Technical product information

Topic	High pitched whistle from the engine - Warning light within the DIP - Engine not running smoothly - Numerous DTC's
Market area	Bentley: worldwide (2WBE)
Brand	Bentley
Transaction No.	2059379/4
Level	EH
Status	Approval
Release date

Bentayga Series - V8 Kovomo

Figure 2

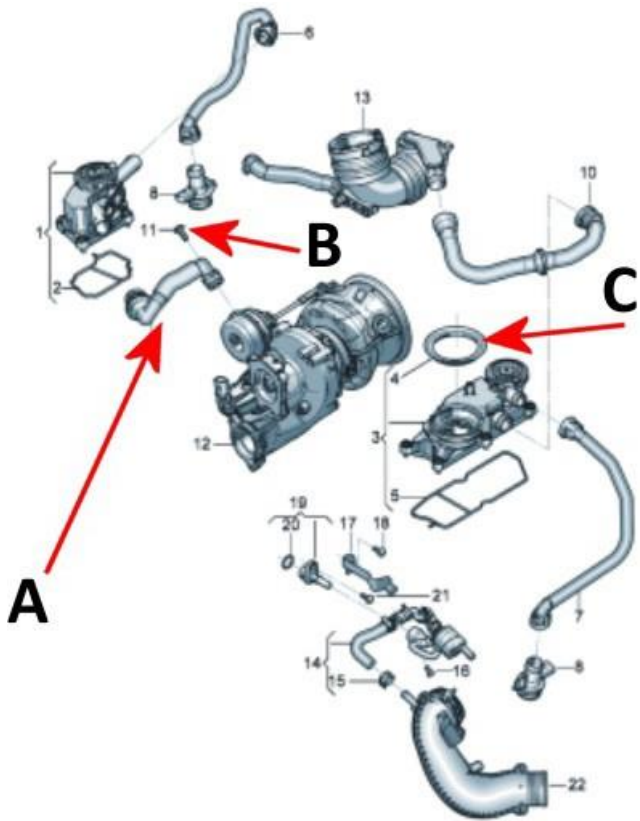
Air intake leak due to a broken one-way diaphragm valve from within the Bank 1 breather line

2) Referring to Figure 2 - Replace the Bank 1 breather line (Point A) and fixing (Point B) – Refer to applicable sections from Rep.Gr 10 - Oil mist separator bank 1 - To remove and fit

- Replace the oil filler pipe seal to the Bank 2 oil separator (Point C)
